OIL - TRANSMITTAL OF CONTINENTAL AEROSPACE TECHNOLOGIES™ SB21-03 OIL TEMPERATURE CONTROL VALVE INSPECTION

SEL-79-04
Page 1 of 3

SERVICE BULLETIN**SB21-03**

TECHNICAL PORTIONS
FAA APPROVED**SUBJECT:** Potential Failure of Oil Temperature Control Valve Part No. 657496**PURPOSE:** Notify customers of nonconformity in Part No. 657496 Oil Temperature Control Valve manufactured in Q4 (fourth quarter) of 2020.**COMPLIANCE:** During the next scheduled oil change, or before next flight if experiencing oil temperature indications near or greater than the specified operating limits.**MODELS****AFFECTED:** Continental Aerospace Technologies new and rebuilt engine model specifications (I0550N, TSI0550C, TSI0550K, TSI0550N, TSI0F550K) using Oil Temperature Control Valve (Vernatherm) Part No. 657496.**I. GENERAL INFORMATION**

**Figure 1. Oil Temperature Control Valve****III. AFFECTED ENGINE SERIAL NUMBERS**

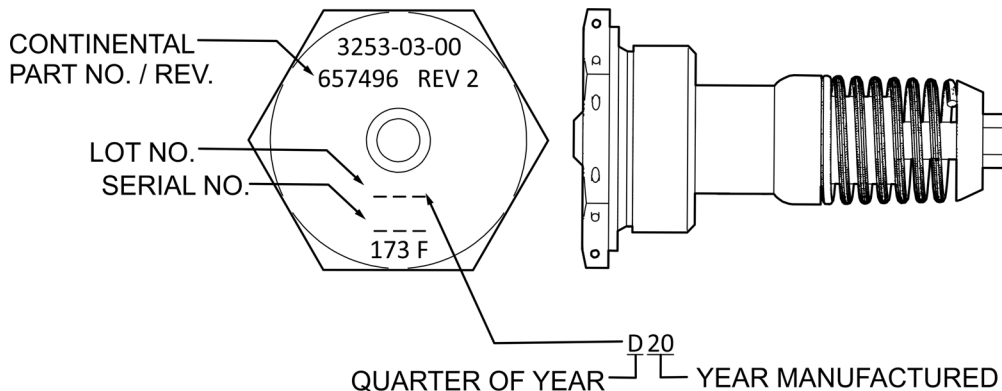
The lot number is etched on the cap of the assembly below the part number in the location shown in Figure 1. Remove and replace affected Part No. 657496, Vernatherm Assembly marked with lot number **D20** (2020Q4) with a serviceable unit.

Remove and replace the Oil Temperature Control Valve (Vernatherm) on affected engines according to the engine instructions for continued airworthiness. If oil temperature exceeds 240°F for more than 30 seconds, perform an oil change according to instructions in M-0, Standard Practice Maintenance Manual.
